Access Compliance Report

Public Rights-of-Way

(Pedestrian Signals)

Intersection ID: N/A	Main Street:	Cross Street: N/A	Location: N/A
ADA ID: 1F94EE911433	Signal Type: One Push Button-APS	Overall Compliance: No	Severity Score: BTN 1: N/A BTN 2: N/A No BTN: N/A
Codes/Mitigation Info/Possible Solution		Field Measurements/Component Compliance

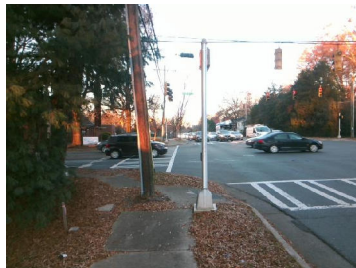
PROW/ADA: R404.2, R404.3, R406.2, DMS-
11132, R209.1, MUTCD 4e.10

Compliance	Description	Data	Compliance	Description	Data
	Button Count	Button1	Yes	Distant to Additional Button (in)	251.0
	Additional Button Present?	Yes		Additional Button ID	5B90868F9D3F
N/A	Signal Buttons Required?	N/A	N/A	Additional Ped Posts Required	N/A
	How Many Ped Street Xings?	2		Located In An Island/Median?	No
N/A	B 1 Sign Present?	Yes	N/A	B 2 Sign Present?	N/A
Yes	B 1 Sign Purpose?	Yes	N/A	B 2 Sign Purpose?	N/A
Yes	B 1 Sign Lettering & Contrast?	Yes	N/A	B 2 Sign Lettering & Contrast?	N/A
Yes	B 1 Parallel To XWalk?	Yes	N/A	B 2 Parallel To XWalk?	N/A
Yes	B 1 PAR to Button?	Yes	N/A	B 2 PAR to Button?	N/A
Yes	B 1 PAR to XWalk?	Yes	N/A	B 2 PAR to XWalk?	N/A
Yes	B 1 Clear Floor Space?	Yes	N/A	B 2 Clear Floor Space?	N/A
N/A	B 1 FWD Approach?	Yes	N/A	B 2 FWD Approach?	N/A
N/A	B 1 FWD Approach Constrained?	No	N/A	B 2 FWD Approach Constrained?	N/A
No	B 1 FWD Approach Reach (in)	4.0	N/A	B 2 FWD Approach Reach (in)	N/A

N/A	B 1 FWD Approach Width (in)	N/A	N/A	B 2 FWD Approach Width (in)	N/A
N/A	B 1 FWD Approach Obstruction?	Yes	N/A	B 2 FWD Approach Obstruction?	N/A
N/A	B 1 FWD Approach Obstruction Dist (in)	2.0	N/A	B 2 FWD Approach ObstructionDist (in)	N/A
N/A	B 1 PARA Approach?	Yes	N/A	B 2 PARA Approach?	N/A
N/A	B 1 PARA Approach Constrained?	No	N/A	B 2 PARA Approach Constrained?	N/A
Yes	B 1 PARA Approach Reach (in)	4.0	N/A	B 2 PARA Approach Reach (in)	N/A
N/A	B 1 PARA Approach Width (in)	N/A	N/A	B 2 PARA Approach Width (in)	N/A
N/A	B 1 PARA Approach Obstruction?	Yes	N/A	B 2 PARA Approach Obstruction?	N/A
N/A	B 1 PARA Approach Obstruction Dist (in)	2.0	N/A	B 2 PARA Approach ObstructionDist (in)	N/A
No	B 1 Clear Floor Space Slope (%)	3.2	N/A	B 2 Clear Floor Space Slope (%)	N/A
No	B 1 Clear Floor Space XSlope (%)	3.1	N/A	B 2 Clear Floor Space XSlope (%)	N/A
N/A	B 1 PAR Slope (%)	1.6	N/A	B 2 PAR Slope (%)	N/A
Yes	B 1 Height (in)	38.0	N/A	B 2 Height (in)	N/A

Yes	B 1 Clear Xing Direction?	ClearlyMarked	N/A	B 2 Clear Xing Direction?	N/A
	B 1 Crossing Direction	To N		B 2 Crossing Direction	N/A
Yes	B 1 DistanceTo XWalk (in)	0.0	N/A	B 2 DistanceTo XWalk (in)	N/A
Yes	B 1 DistanceTo Curb (in)	41.0	N/A	B 2 DistanceTo Curb (in)	N/A
No	B 1 Diameter (in)	2.2	N/A	B 2 Diameter (in)	N/A

Possible Solutions: Remove & Replace
Replace APS Button With New APS Button.
Provide Push Button Extension. Remove and
Replace Clear Space.
